**CITY OF SAINT PAUL
HERITAGE PRESERVATION COMMISSION STAFF REPORT**

FILE NAME: 214 Fourth Street East
DATE OF APPLICATION: March 7, 2013
APPLICANT: Ramsey County Regional Rail Authority
OWNER: Ramsey County Regional Rail Authority
DATE OF REVIEW: March 28, 2013
HPC SITE/DISTRICT: Union Depot/Lowertown Historic District
CATEGORY: Pivotal
CLASSIFICATION: Building Permit
STAFF INVESTIGATION AND REPORT: Bill Dermody REV. by Amy Spong
DATE: March 22, 2013 Revised March 27, 2013

St. Paul Union Depot.
Carriageway.
date. 02.26.2013

Rightside...begining at VENT

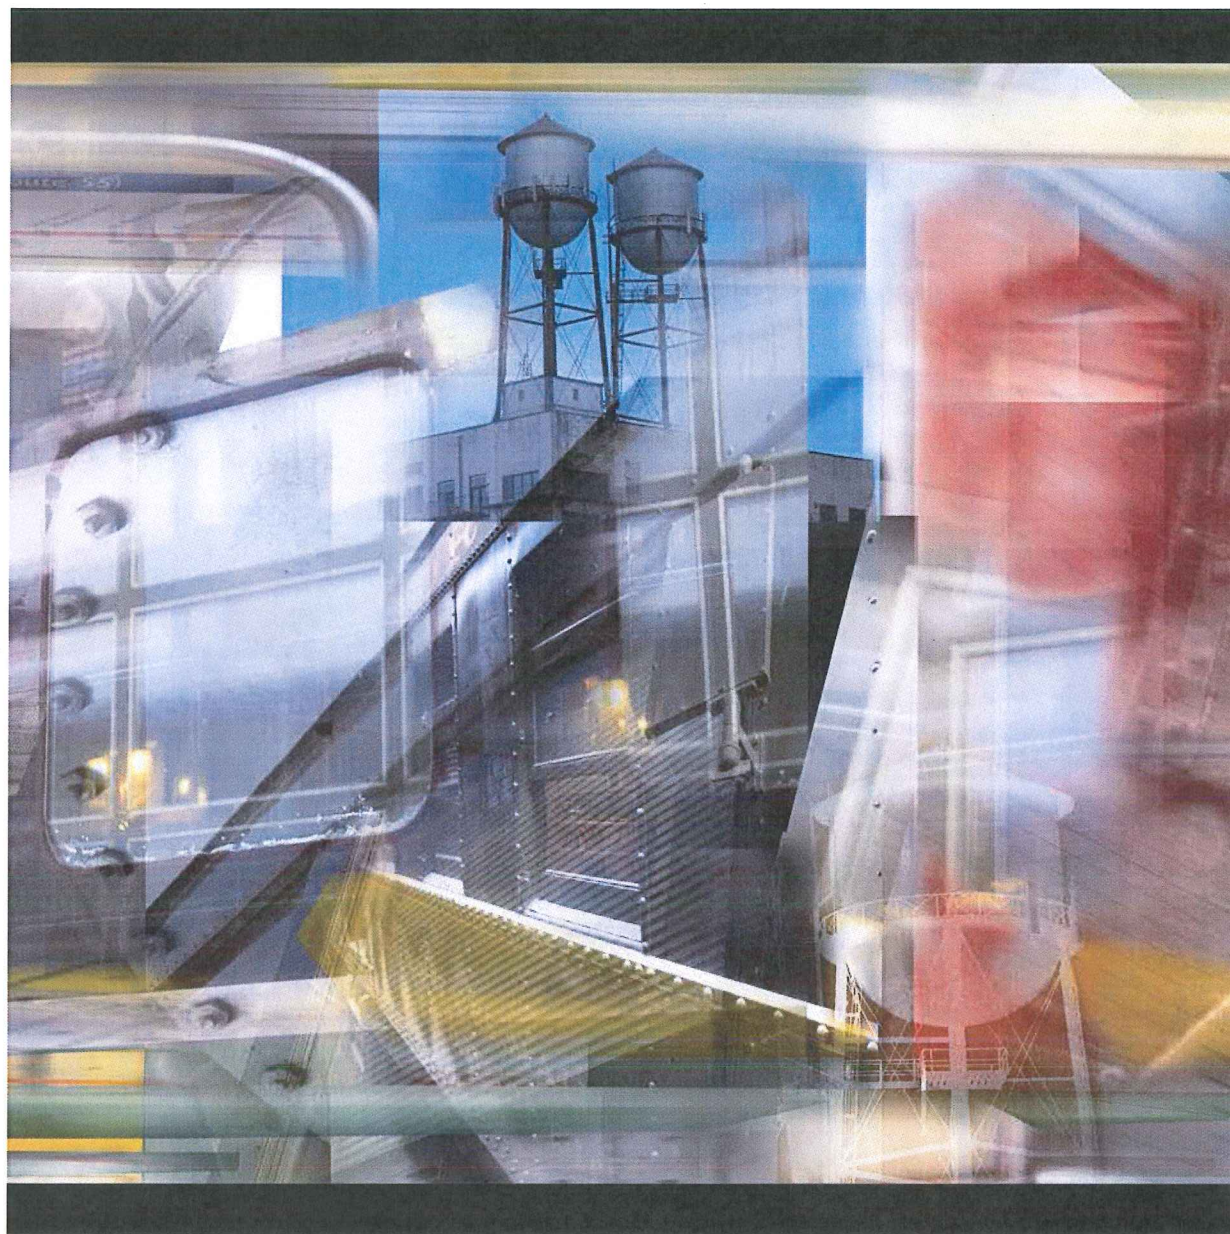
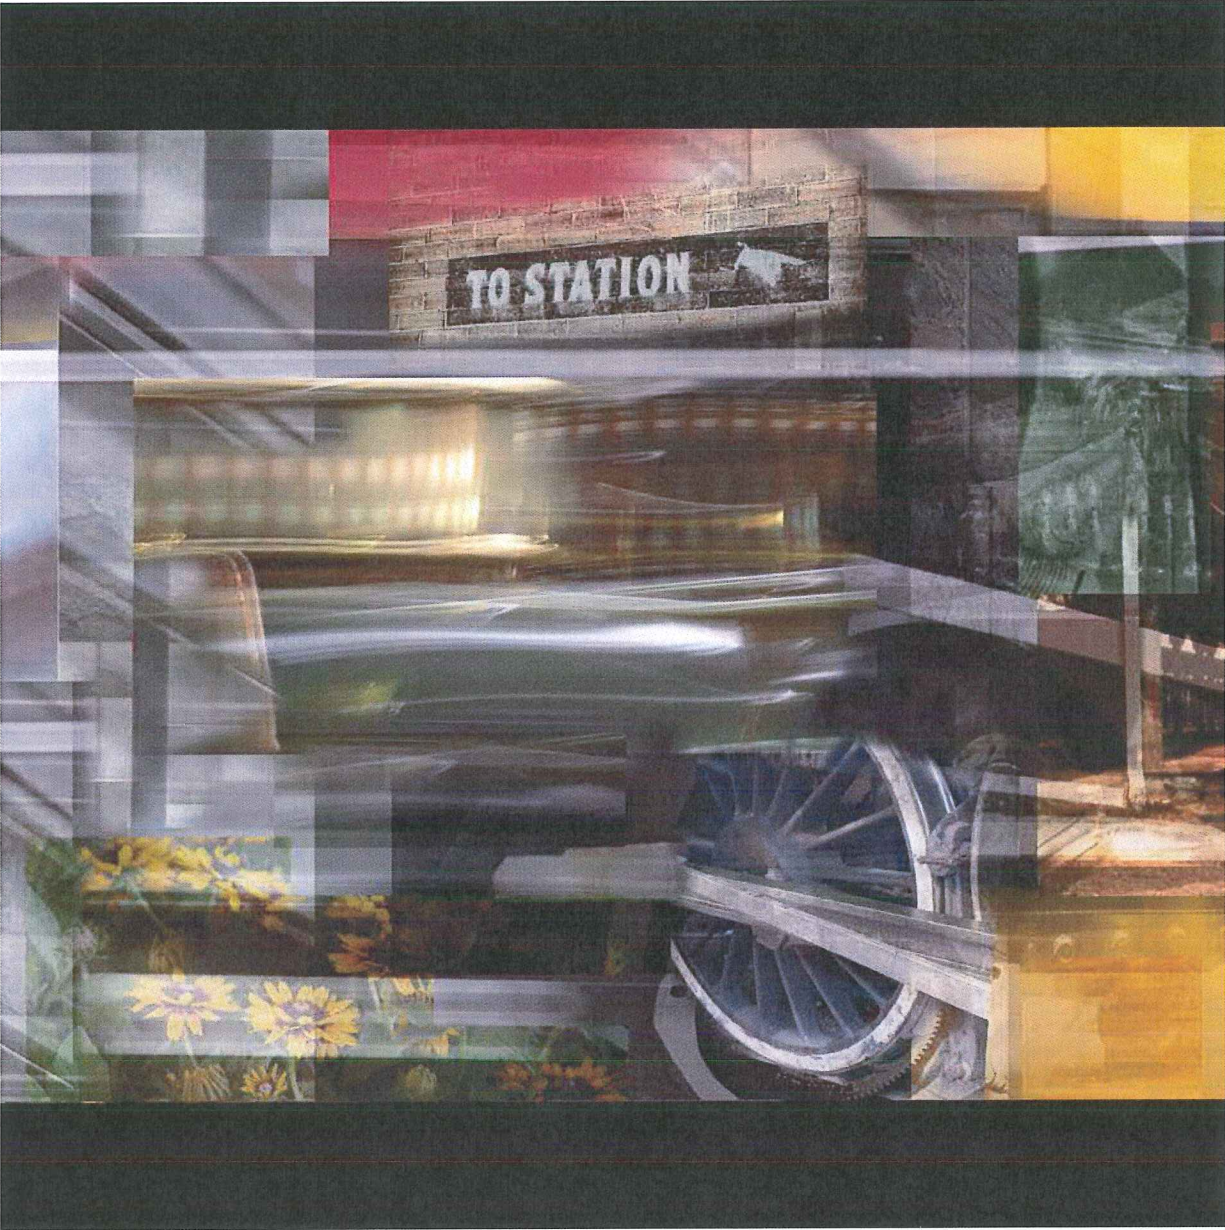
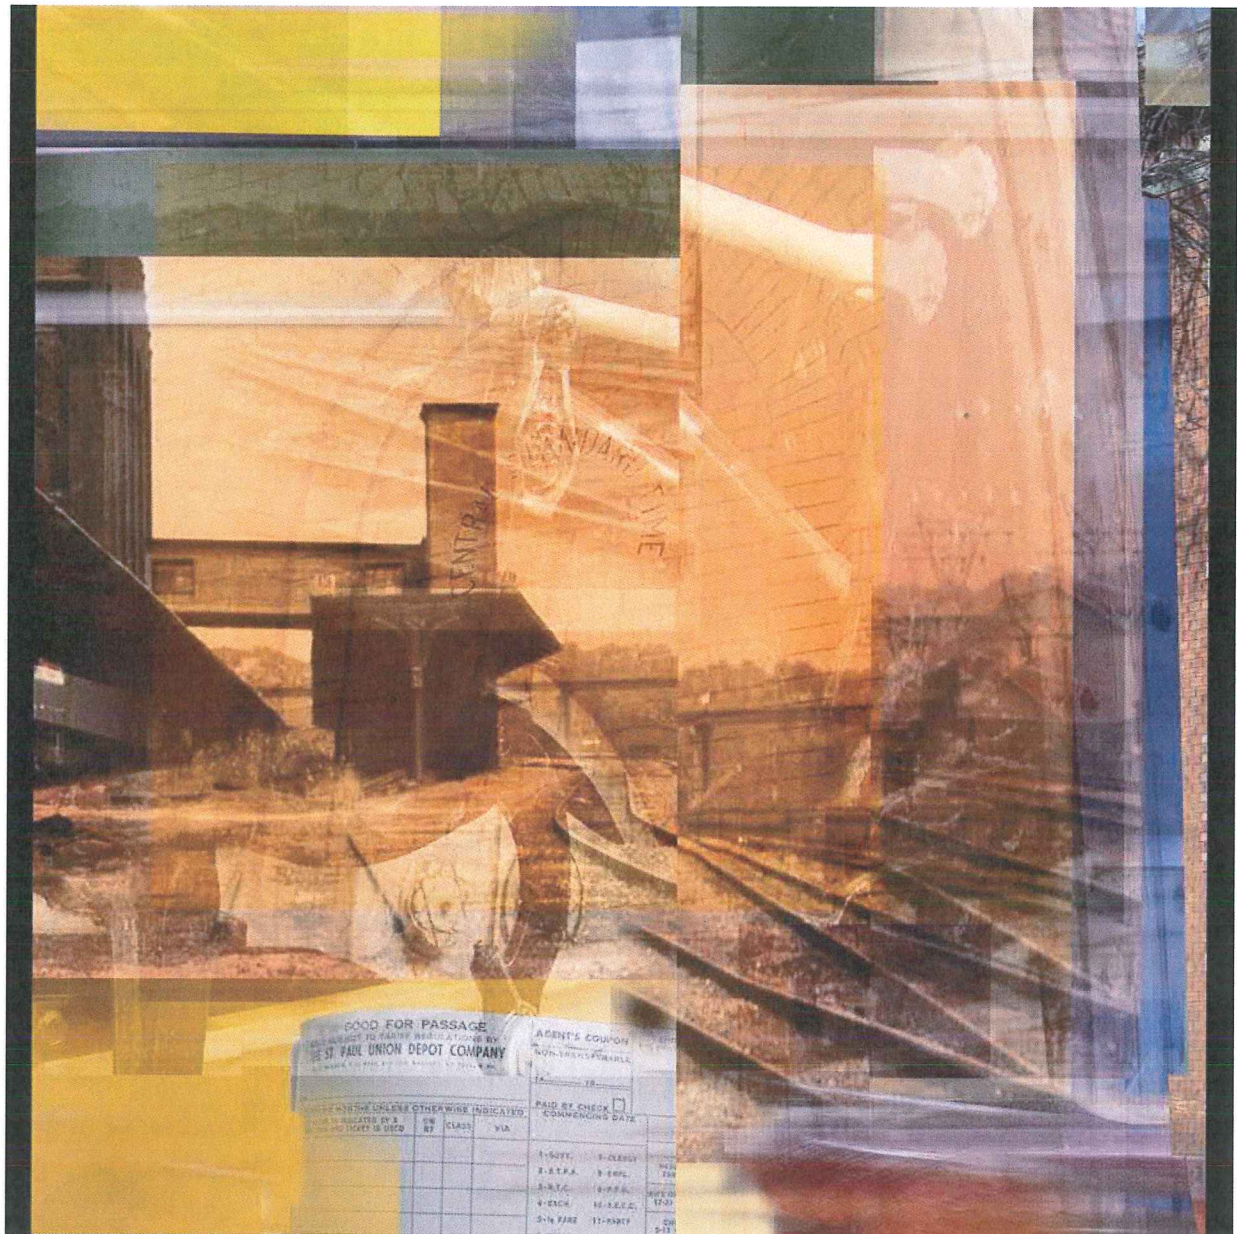
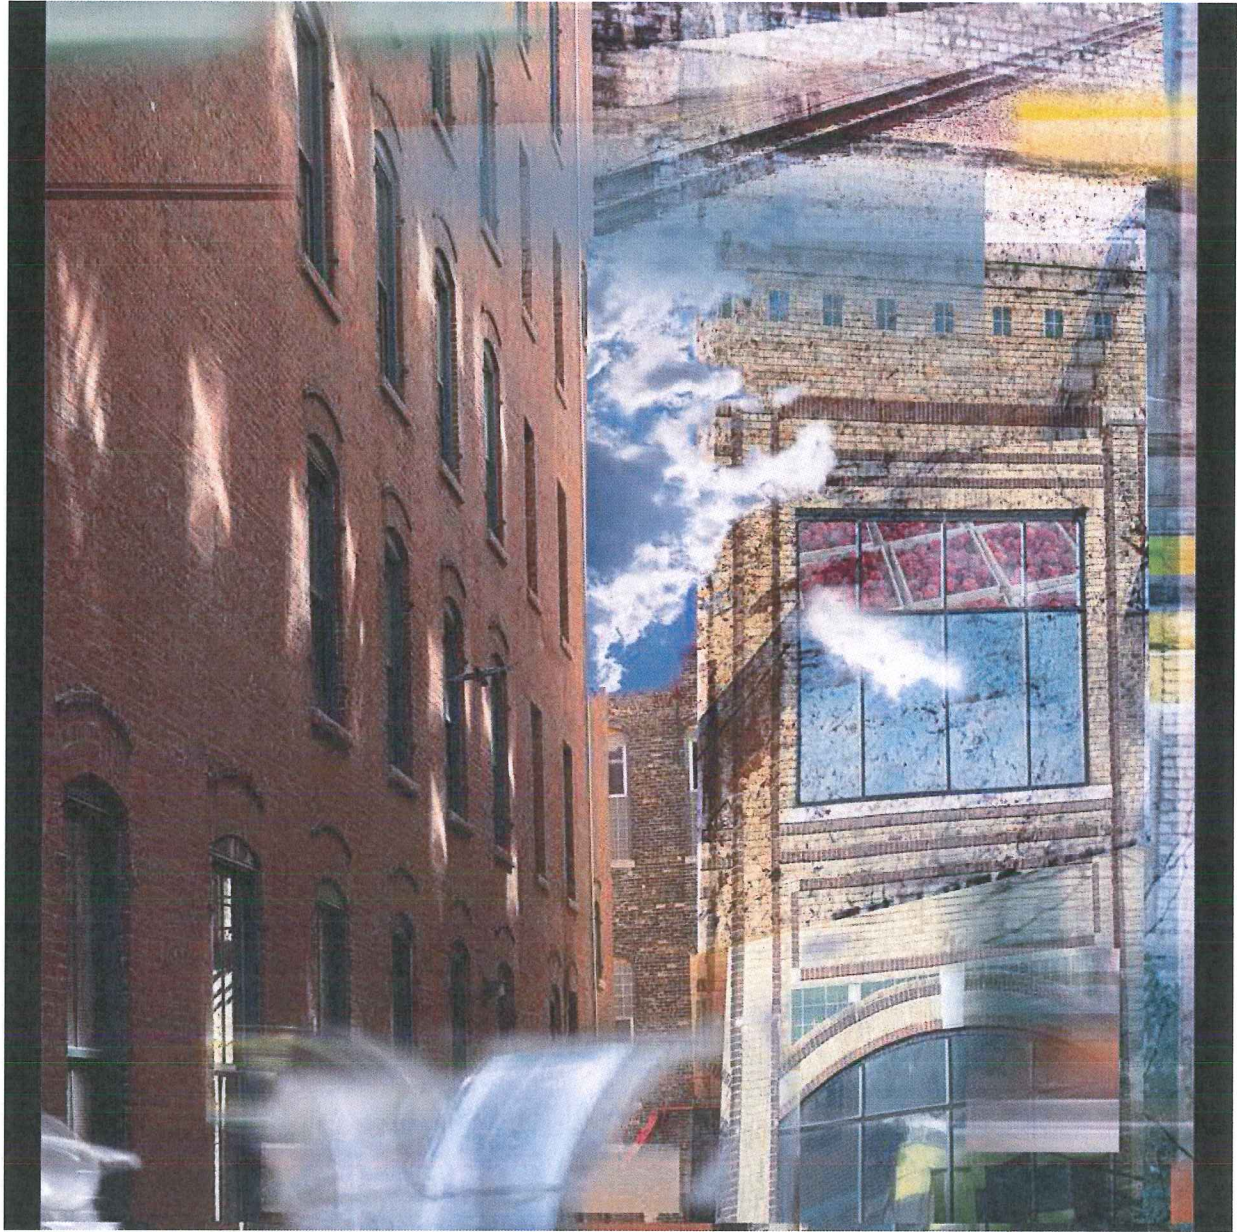
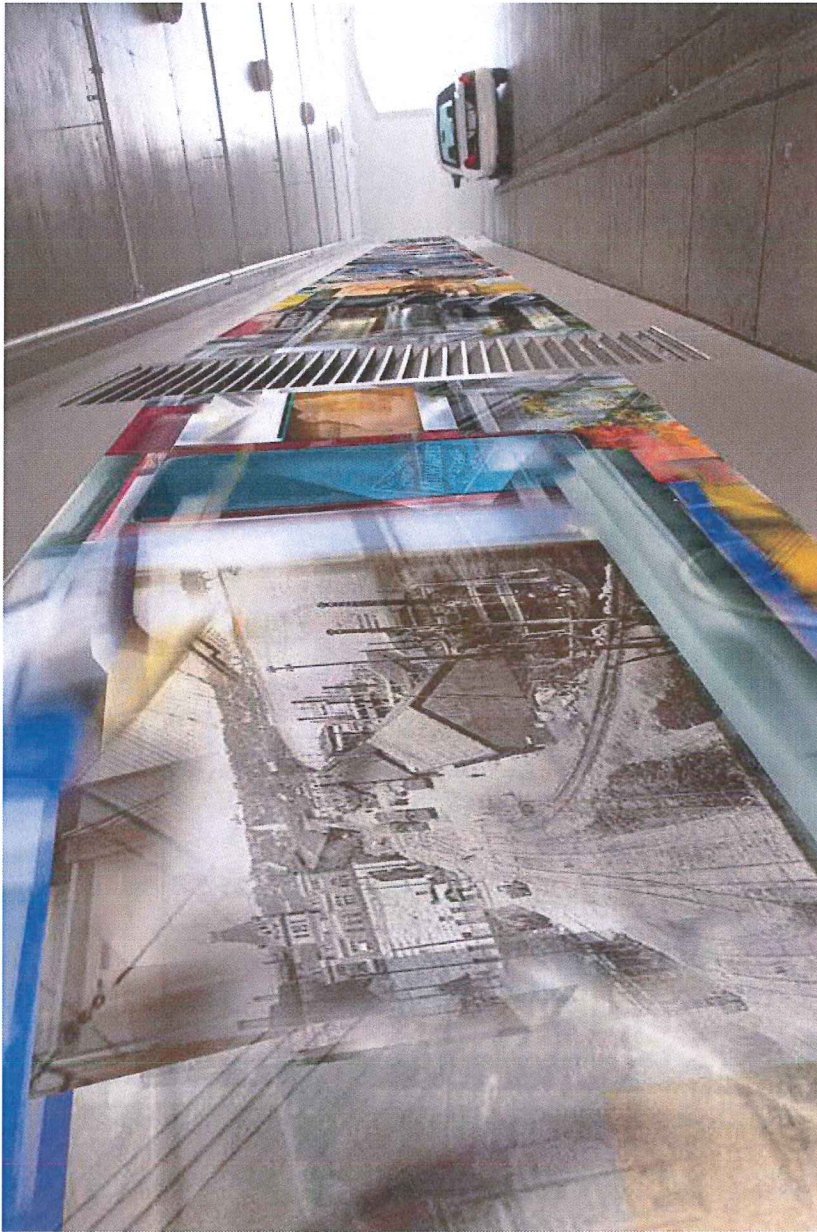
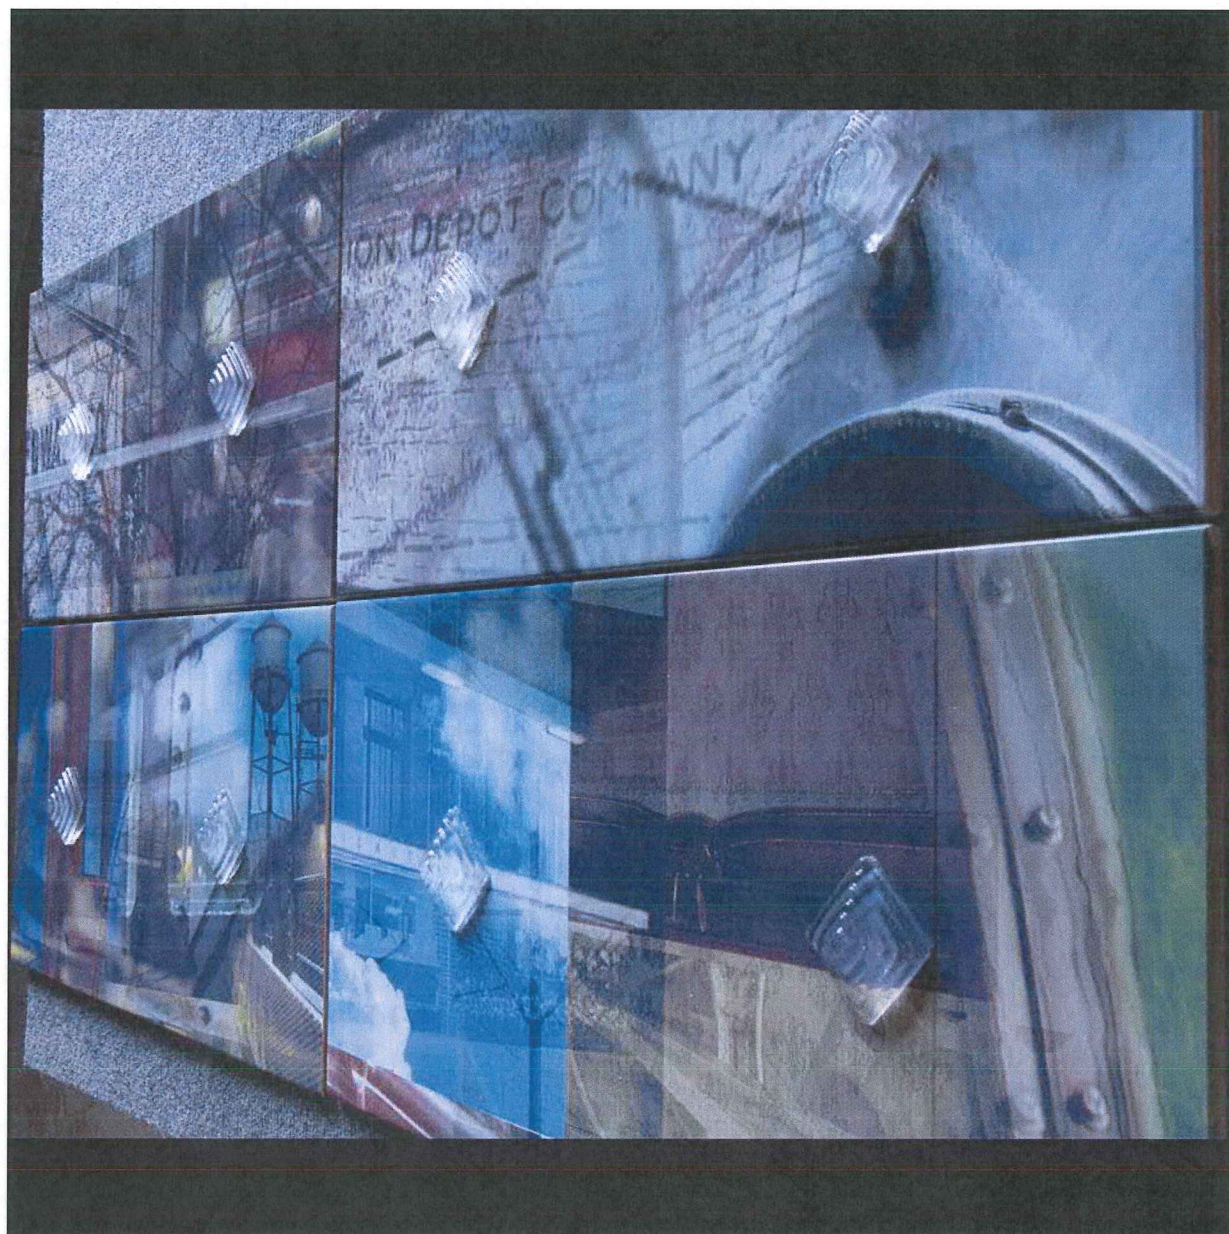
The mural contains historic and existing images from the site, the surrounding area of Lowertown, and elsewhere (Downtown, University Avenue, West Side). Also, several images relate to trains, including a historic locomotive, train wheels and windows, and signage. The Lowertown and Downtown images portray current buildings that might have been viewed historically by passengers debarking at Union Depot. The University Avenue images include buildings that might be seen by passengers on the new Green Line light rail transit service that begins operation in 2014.

The images relating to trains, the Union Depot site, and Lowertown are appropriate because they foster an understanding of the site's historic context as a pivotal building within the Lowertown Historic District. However, images from elsewhere (Downtown, University Avenue, West Side) are not necessarily consistent with the historic context at this location.

4. *Materials.* The glass-laminated tile is not an existing building material. The proposed material is appropriate at this location given much of this area is new construction and the historic character of the original carriageway is not present on the south side of the carriageway.

5. *Method of Attachment.* Attachment methods were not included in the application and should be submitted for review. There is no historic fabric that would be damaged through installation and the mural will not *disfigure or conceal architectural details*.

6. *Lighting.* Additional lighting is proposed but a specific proposal was not submitted. Guidelines state, "*Location of exterior lights should be appropriate to the structure. There should be no flashing, blinking, moving, or varying intensity lighting. Subdued lighting is preferred. Backlit fluorescent or exposed neon are generally inappropriate.*" The application also states the mural itself will have some reflectivity as vehicle headlights move through the space.

1. Final drawings shall be submitted to staff for final review and approval. These final details shall include, but not be limited to, method of attachment, section drawings showing panel specifics, lighting fixtures and placement, and material mockups. Staff shall review and approve final details.
